SAFETY RELATED RECALL

Global Recall Action
Number: D113

Subject: Defender 110 Third Row Seatbelt Mounting Bracket - Incorrect Specification	Publication No.: D113
	Model: Defender (LE)
	Model Year: 2026
	Date of Issue: 31 March 2026

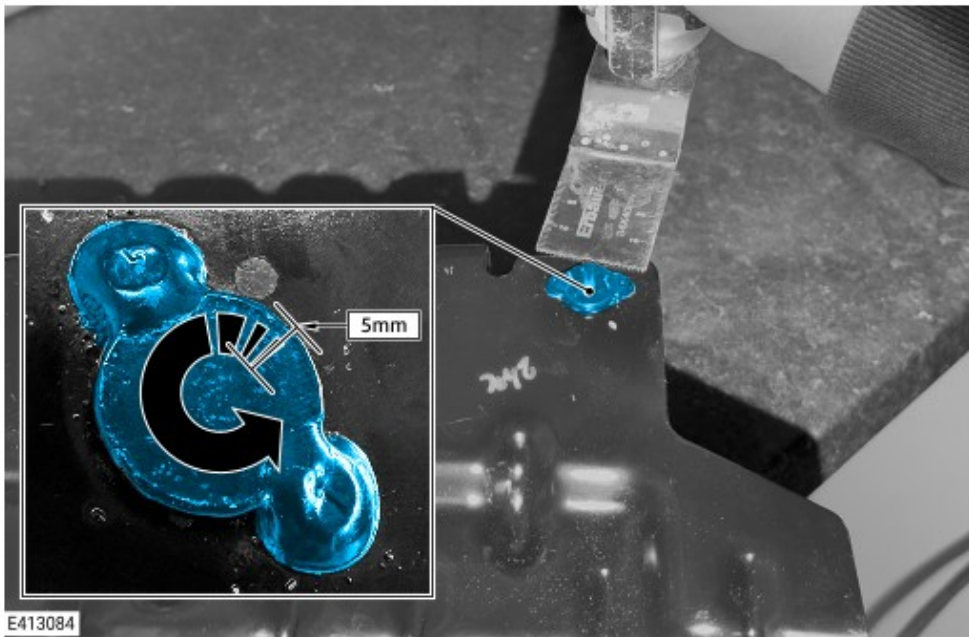
- A titanium carbide or obsidian carbide oscillating multitool blade can help with this step but is not essential.
- The multitool blade must be flat to the surface of the third row seatbelt anchor bracket at all times.

- Cut through the 2 welds securing the stud to the third row seatbelt anchor bracket.
- Cut a minimum of a 5 mm deep groove below the stud head and around the entire circumference of the stud.

10. Remove the stud from the third row seatbelt anchor bracket.

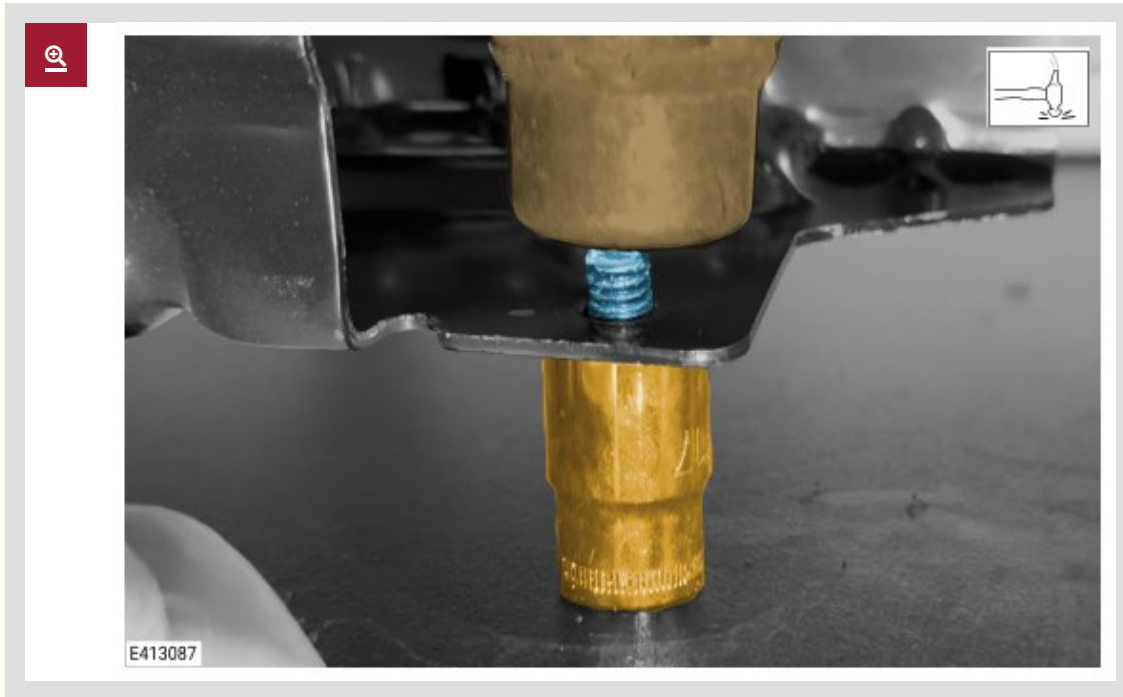
- Remove the third row seatbelt anchor bracket from the vice.
- Rest the bracket on a suitable size socket, or similar tool, with the thread of the stud pointing upwards, as shown in the illustration.
- Using a suitable hammer and punch, hammer the stud out of the third row seatbelt anchor bracket.
- The third row seatbelt anchor bracket must be straight, without deformities, before continuing.

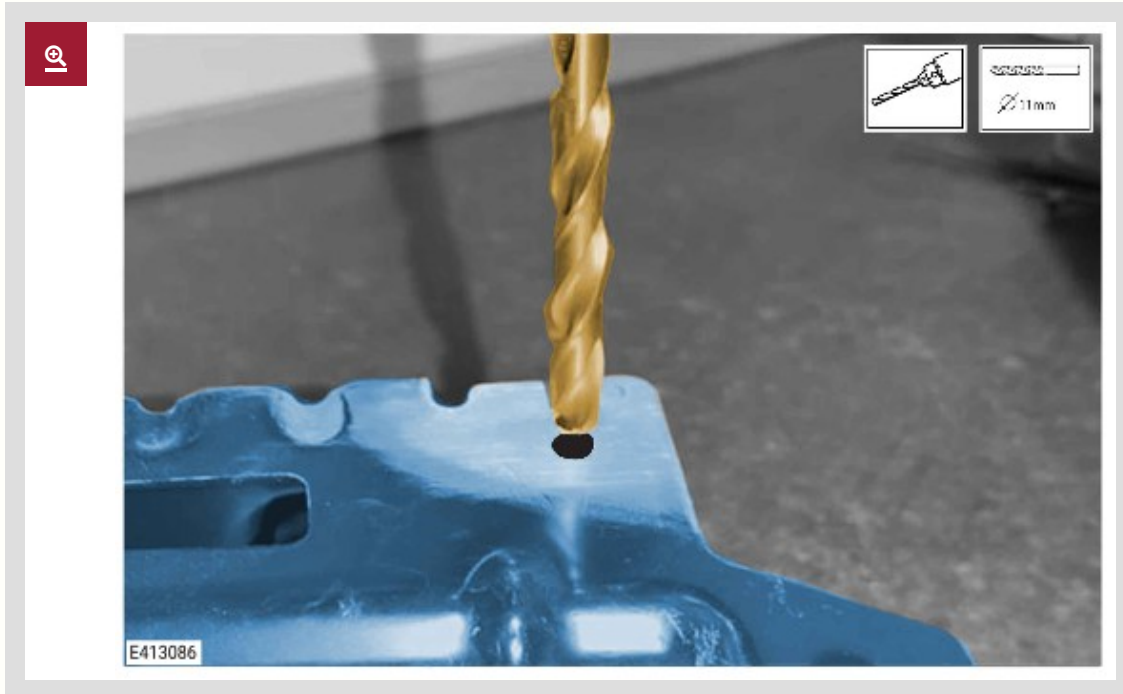
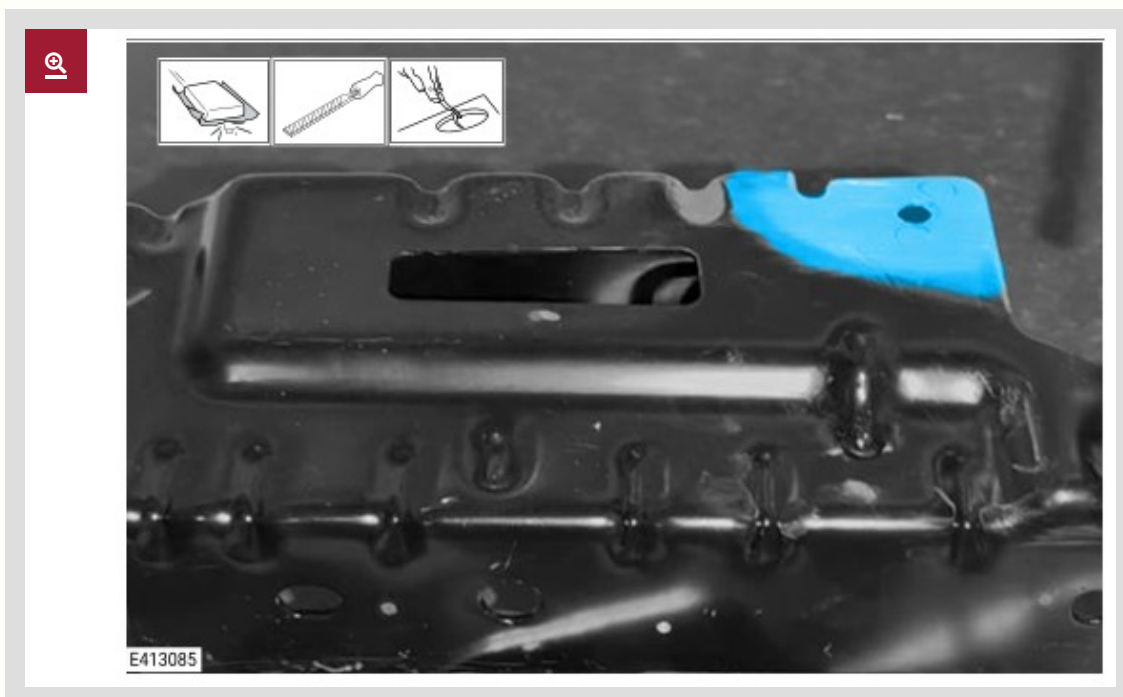
The drill must be upright and central at all times.

Enlarge the existing hole in the third row seatbelt anchor bracket using an 11 mm drill bit.

12. Using a suitable file and abrasive paper, flatten the surface of the third row seatbelt anchor bracket. The hole must be free of material before continuing.

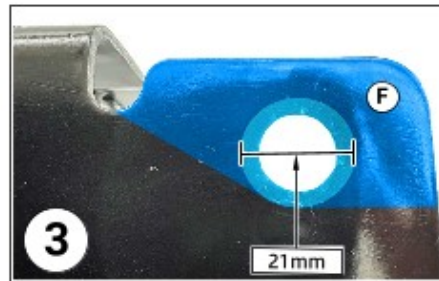
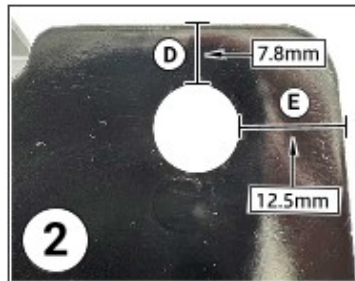
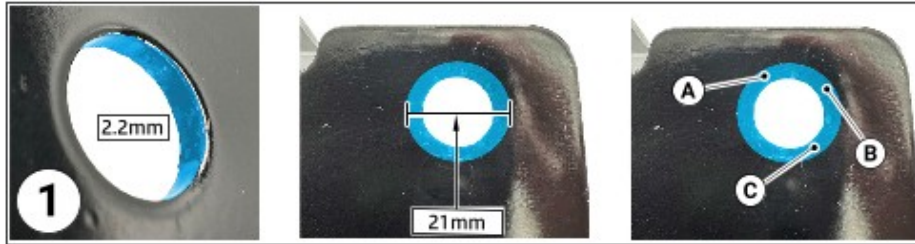
If **1 or more** of the below requirements cannot be achieved, a new third row seatbelt anchor bracket **MUST** be installed, continue to quarantine the vehicle and await a further communication. Do **NOT** install any third row seatbelt anchor bracket which does not meet **1 or more** of the below requirements.

Complete the following 4 steps, the modified third row seatbelt anchor bracket must meet the requirements. Take a photograph to show each of the below measurements being completed, including a photograph of the area to be inspected in step 3. The photographs must be attached to the Warranty Claim. Failure to follow this instruction may result in a rejection or delay in the claim being processed.

1. Using the images provided for reference, measure the thickness of the third row seatbelt anchor bracket. There must be a **minimum** thickness of 2.2 mm within the 21 mm perimeter around the drilled hole. Also, specifically measure the thickness of the areas marked A, B, and C. The deviation in thickness across points A, B, and C **MUST NOT** exceed 0.5 mm.

2. Measure from the edge of the drilled hole to the edge of the third row seatbelt anchor bracket, in the areas shown.
 - D) There **MUST** be a **minimum** of 7.8 mm from the edge of the drilled hole to the edge of the third row seatbelt anchor bracket, in the area shown.

- E) There **MUST** be a **minimum** of 12.5 mm from the edge of the drilled hole to the edge of the third row seatbelt anchor bracket, in the area shown.

3. Visually inspect the wider area of the third row seatbelt anchor bracket shown as Dark Blue in the illustration and marked F. Inspect for any incidental damage caused during steps 9 to 12. Any incidental damage present **MUST NOT** reduce the thickness of the third row seatbelt anchor bracket to less than 2.2 mm in the area shown.

4. Measure the diameter of the drilled hole. The diameter of the drilled hole **MUST** measure between 10.7 mm - 11.5 mm.

14. Paint the bracket following the instructions below.

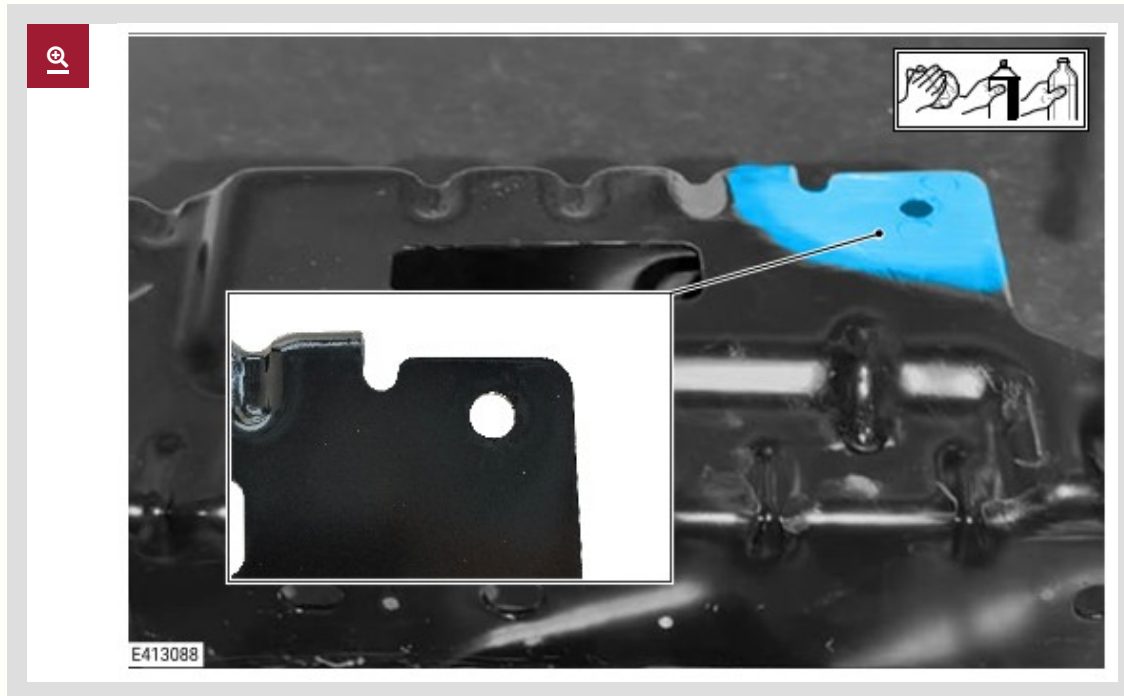
- Clean the flattened area of the bracket to remove contamination.
- Apply a layer of suitable aerosol etch primer and allow to cure following the manufacturers specifications.
- Apply a layer of suitable black aerosol paint and allow to cure following the manufacturers specifications.

18. Tighten the 6 nuts as shown in the illustration.

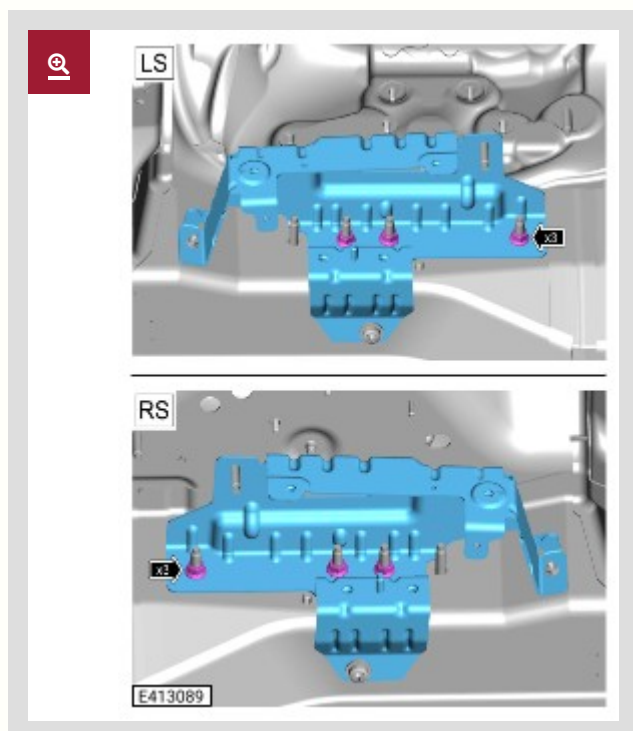
- Torque: **45Nm**

19. Tighten the 2 nuts and 2 bolts as shown in the illustration.

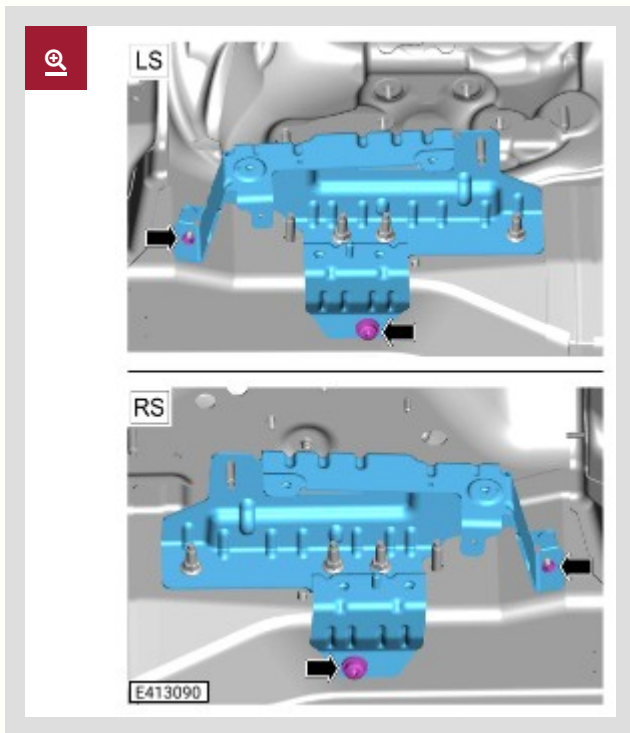
- Tighten the nuts.
 - Torque: **10Nm**
- Tighten the bolts.
 - Torque: **48Nm**

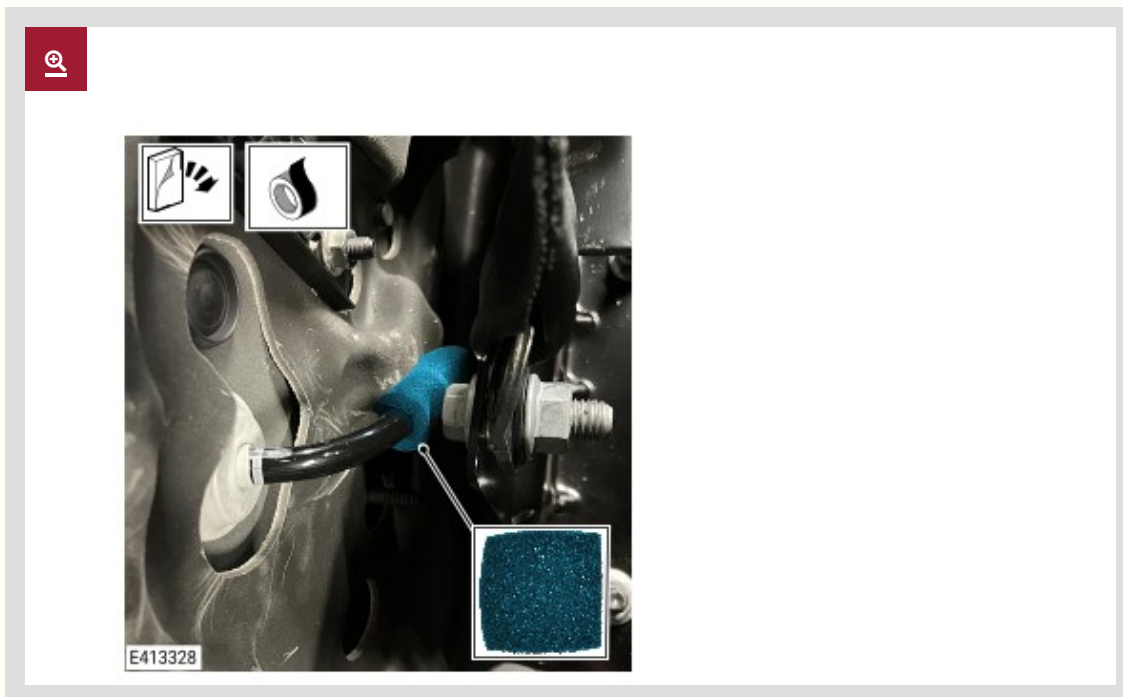
The energy absorbing foam tape foam is required prevent any contact between the air suspension pipe and the head of the bolt.

Right third row seatbelt bracket only.

Install the energy absorbing foam tape.

- Install the energy absorbing foam tape onto the air suspension pipe, as shown in the illustration.
- Apply a suitable anti-abrasion tape to the foam [Noise, Vibration and Harshness \(NVH\)](#) pad.
